KH9(-B)Indoor Station
Version: V2.1.48_build220620
Release Note
(2022-08-02)

Version: V2.1.30_build220402

Release Note

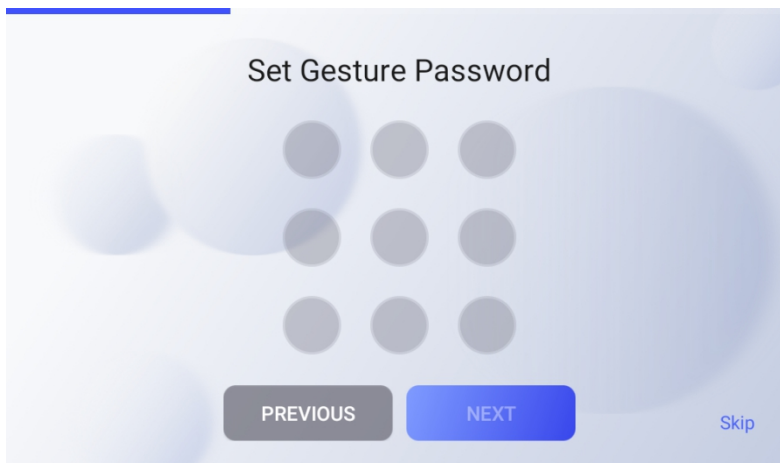
1) Support reset admin password via email or security questions.

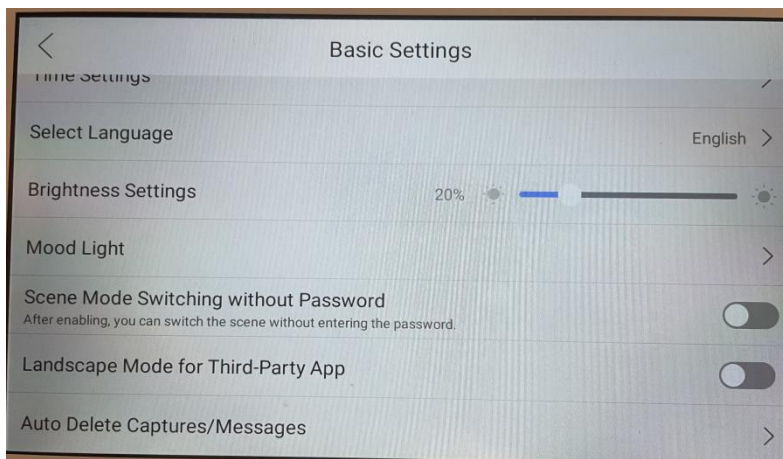
2) Support unlock via gesture.

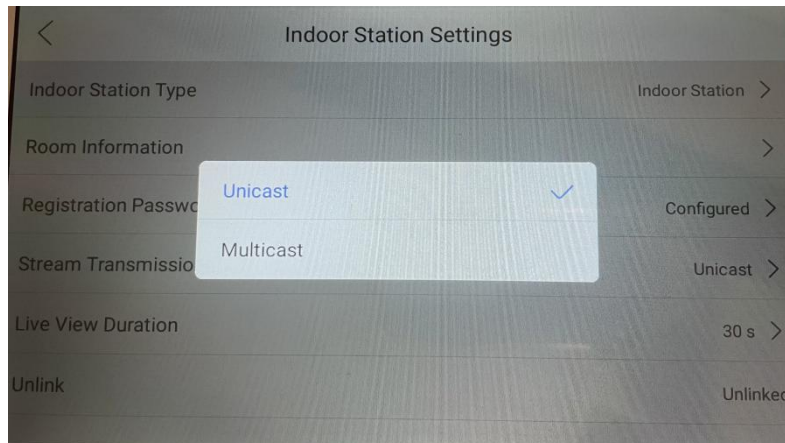
1) Support unicast and multicast options for video stream.

For multicast mode, the new version is supported up to 15 channels of video stream, but the switch or router must support the multicast mode at the same time, otherwise it can only support 6 channels of video stream.

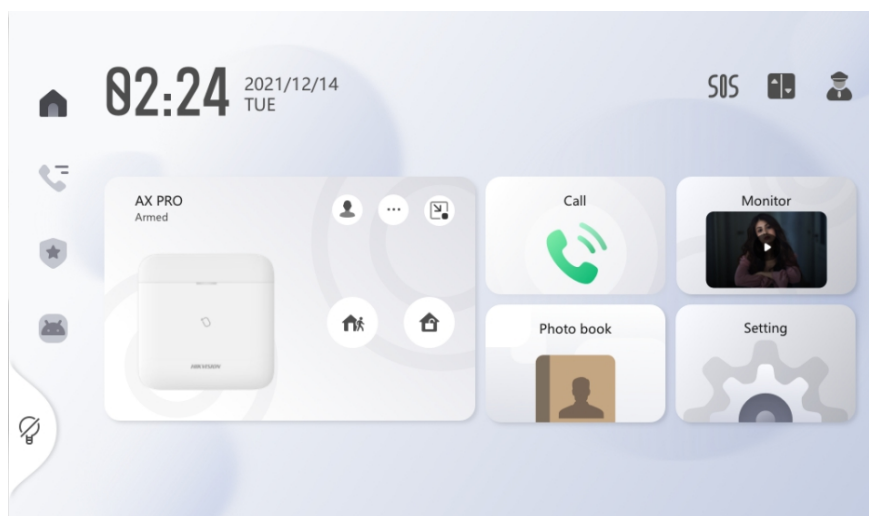
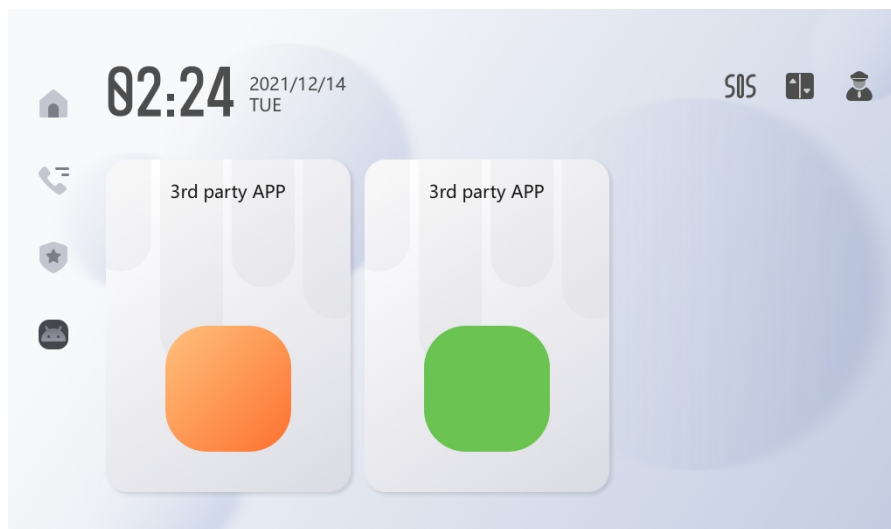
2) 22 languages are supported

English, French, Portuguese (Brazil), Spanish, Russian, German, Italian, Polish, Arabic, Turkish, Vietnamese, Hungarian, Dutch, Romanian, Czech, Bulgarian, Ukrainian, Croatian, Serbian, Greek, Norwegian, Danish
